SUBJECT: Forwards evaluation & revised pages to Upgrading Licensing Rept, (WCAP-14276, Rev 1) w/respect to reactor coolant flow-low reactor trip setpoint used in analyses.

L-96-176

Re: Turkey Point Units 3 and 4
Docket Nos. 50-250 and 50-251
Updated Analysis
Proposed License Amendments
Thermal Power Uprate

Figure 3.2.8-5 Flow Coastdown versus Time
Partial Loss of Forced Reactor Coolant Flow
(All loops initially operating, two loops coasting down)

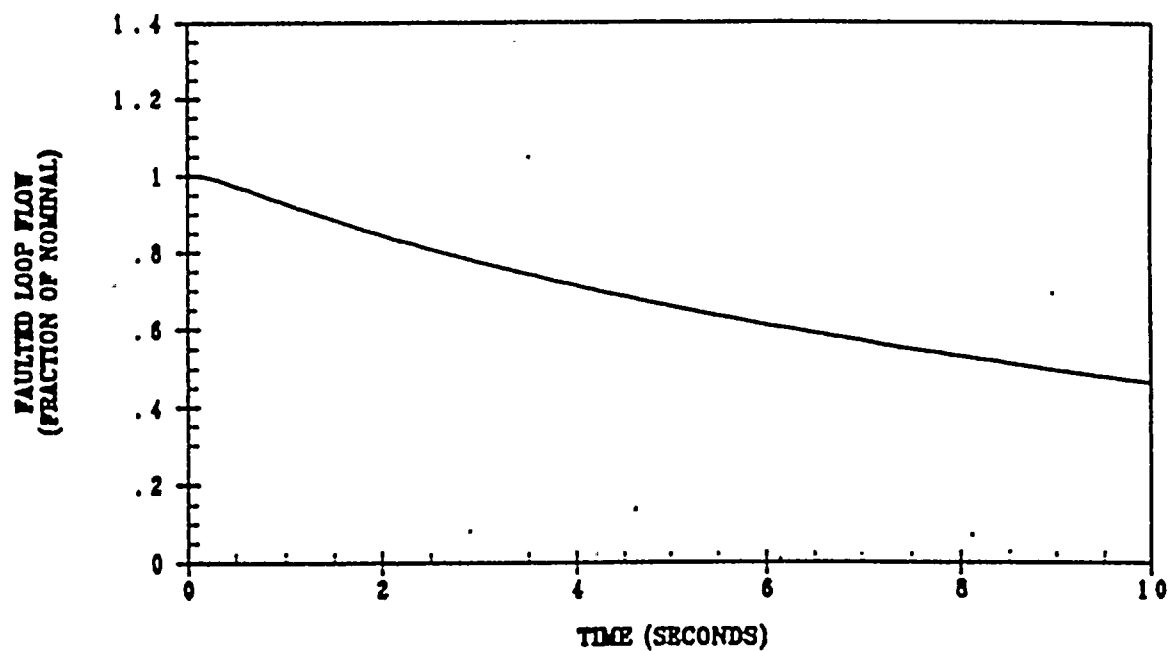
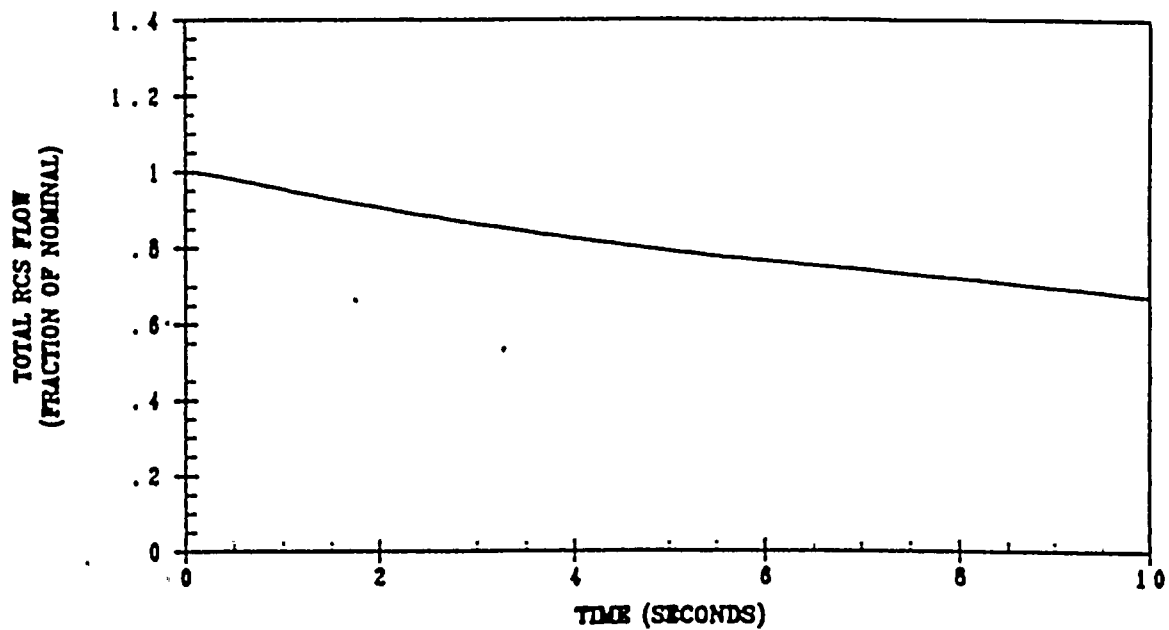
For the Partial Loss of Forced Reactor Coolant Flow, the impact of the change in setpoint value is a delay of 0.3 seconds in the time of trip actuation. The original analysis resulted in a time to reactor trip of 2.0 seconds. The revised analysis establishes a time to reactor trip of 2.3 seconds. This delay has no significant impact on the results of the transient. Updated pages 3-69, 3-76, 3-77, 3-78 and 3-79 of the Uprating Licensing Report (WCAP-14276, Revision 1) which reflect the revised analysis are provided in Attachment 2.
